16 SECTION AA AS AS PROPOSED

PICARDI ARCHITECTS	119 OXFORD GARDENS LONDON W10 6NE TEL. 020 89600383
TITLE	JOB NO OS20
70 OAKLEY SQUARE, LONDON NW1	DRG NO 16 REV A
ALTERATIONS & REFURBISHMENT	DATE OCT 2020
SECTION AAAS PROPOSED	SCALE 1:50@A2 / 1:100@A4

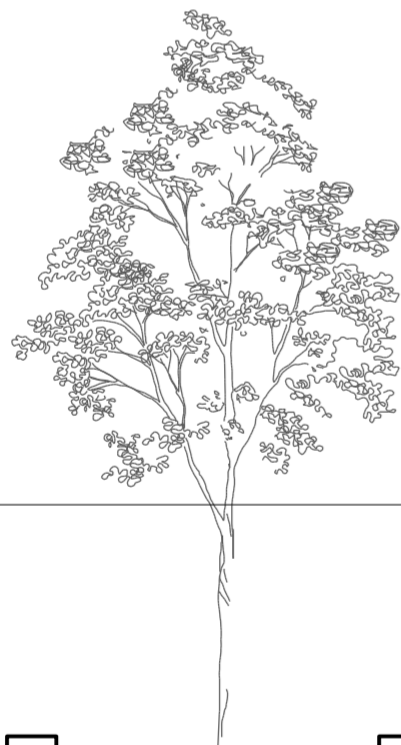
REVISIONS	NOTES
REV.A 22.03.21: AMENDED TO PLANNER'S COMMENTS. PROPOSED ROOFLIGHTS 1,2 & 3 OMITTED, HIGH LEVEL SET BACKS ADDED TO BATHROOM PARTITIONS AT 2ND & 3RD FLOORS, SINGLE GLAZING NOTE ADDED	1. ALL DIMENSIONS TO BE CHECKED ON SITE
	2. THIS DRAWING IS COPYRIGHT OF PICARDI ARCHITECTS
	3. THIS DRAWING DOES NOT FORM PART OF A STRUCTURAL SURVEY
